Intel® Pentium® 4 Processor

Specification Update

October 2003

Document Number: 249199-042

Figure System Bus Reset and Configuration Timings

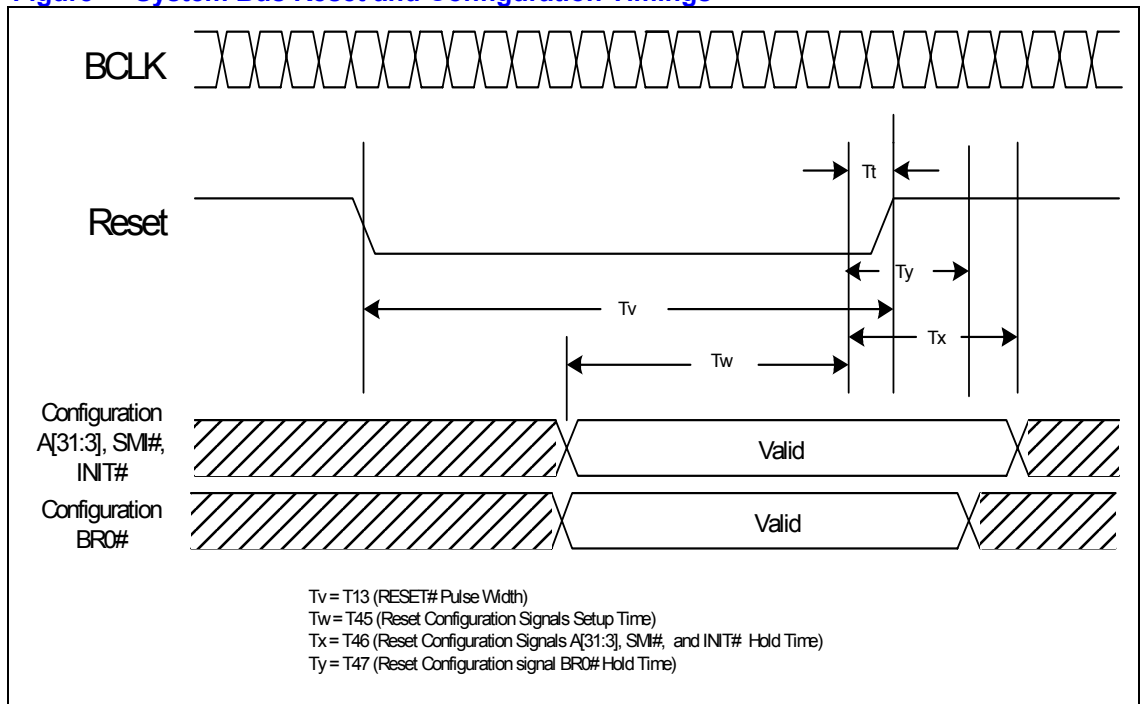
N2. BR0# Maximum Hold Time Specification Change

The BR0# maximum hold time has changed to 2 BCLKs. This change will be shown in the “System Bus AC Specifications (Reset Conditions)” table and “System Bus Reset and Configuration Timings” figure of the *Intel® Pentium® 4 Processor with 512-KB L2 Cache on 0.13 Micron Process EMTS* and *Intel® Pentium® 4 Processor in the 478-pin Package Electrical, Mechanical, and Thermal Specifications (EMTS)* and *Intel® Pentium® 4 Processor in the 423-pin Package Electrical, Mechanical, and Thermal Specifications (EMTS)*. These changes will be incorporated in the next revision of the EMTS (Datasheet).

The following figure will be modified to reflect this change:

T# Parameter	Min	Max	Unit	Figure	Notes
T45: Reset Configuration Signals (A[31:3]#, BR0# INIT#, SMI#) Setup Time	4		BCLKs	12	1
T46: Reset Configuration Signals (A[31:3]#, INIT#, SMI#) Hold Time	2	20	BCLKs	12	2
T47: Reset Configuration Signal BR0# Hold Time	2	2	BCLKs	12	2
